**ADDENDUM NO. 2  
TO THE CONTRACT DOCUMENTS  
FOR THE CONSTRUCTION OF  
Brine Pump Station and Maintenance Facilities Project**

Date: August 2, 2018

The following changes, additions, and/or deletions are hereby made a part of the Contract Documents for the Construction of the Brine Pipeline Pump Station and Maintenance Facilities Project, dated June 2018 as fully and completely as if the same were fully set forth therein:

3. A graphical representation of the operation scenarios required of the Brine Pumps is as follows:

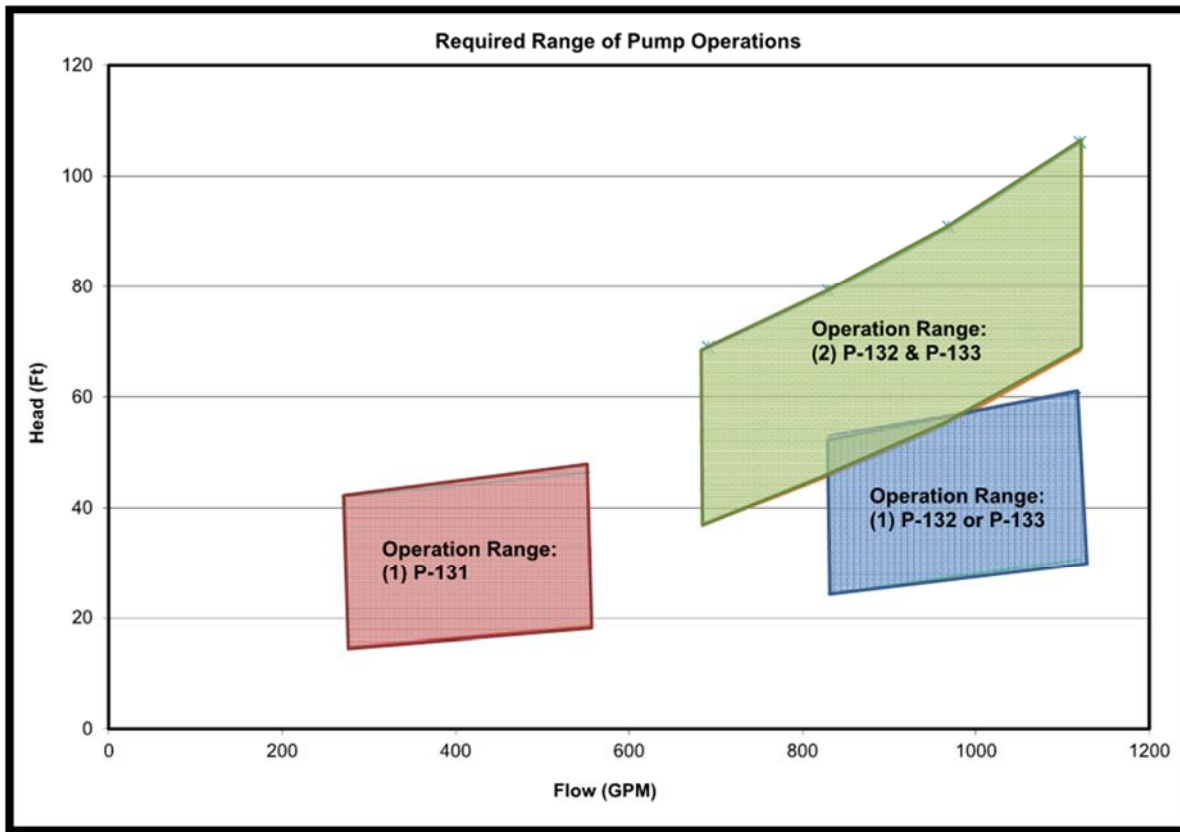
EDR WTP Operational Scenario (# Trains)	Capacity (GPM)	Maximum Head* (ft.)	Minimum Head * (ft.)	Required Bowl Efficiency	Comments
0	0	41	14	-	Static Lift
1	277	42	15	74% minimum	At reduced speed. Secondary performance point.
2	555	46	19	80% minimum	Most common (primary) operating point: May be at full speed or at reduced speed. Basis of design and selection.

EDR WTP Operational Scenario (# Trains)	Total Flow (GPM)	Flow Each Pump (Capacity, GPM)	Maximum Head* (ft.)	Minimum Head * (ft.)	Pumping Scenario	Required Bowl Efficiency	Comments
0	0	0	41	14	-		Static Lift
3	830	830	53	24	1 Pump: P-132 or P-133	70% Min	At reduced speed. Secondary performance point.
4	1120	1120	61	31	1 Pump: P-132 or P-133	70% Min	At reduced speed. Secondary performance point.
5	1383	692	69	37	2 Pumps: P-132 & P-133	70% Min	At reduced speed. Secondary performance point.
6	1660	830	79	46	2 Pumps: P-132 & P-133	74% Min	At reduced speed. Secondary performance point.
7	1937	969	91	55	2 Pumps: P-132 & P-133	81% Min.	<i>Most common (primary) operating point: Basis of design and selection.</i>
8	2240	1120	106	68	2 Pumps: P-132 & P-133	78% Min.	At full speed. Secondary performance point.

4. \*Note performance points indicated are for the required flow and head conditions at the centerline of the discharge flange. Supplier to account for head losses within the column and other internal pump components and the water surface and pump system elevations in the design of the pump.

Figure 1 - Brine Pump Potable Water Flushing and Lubrication Seal-Piping.

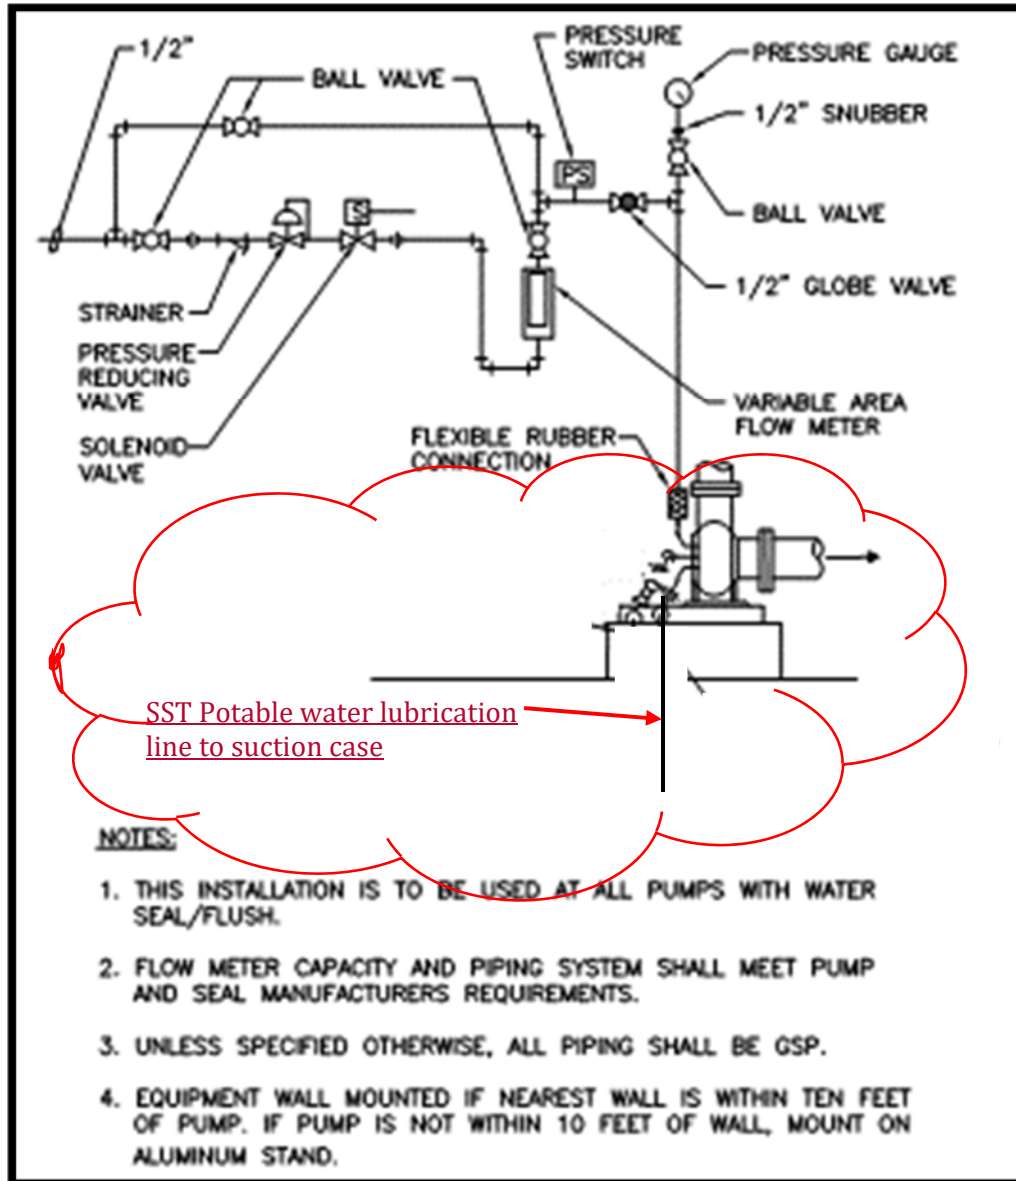
- A. All brine pumps shall be equipped with potable water flushing and lubrication ~~and seals~~ line. For clarity, ~~seal~~ the pump's waterlines are not shown on the drawings ~~plan view~~, but detailed below to be coordinated by the pump manufacturer.
- B. The required piping and control vavles of these potable water flushing and ~~seal~~ lubrication water system for each brine pump shall be as indicated in the Figure 1 below and shall be coordianted and sized with the pump manufacturer. The piping shall be connected to the potable water line mounted around the building and shall be mounted on the wall adjacent to each pump. Piping shall extend to the pump overhead, supported from the ceiling with pipe supports at a minimum 9'-00" height above the finish floor.
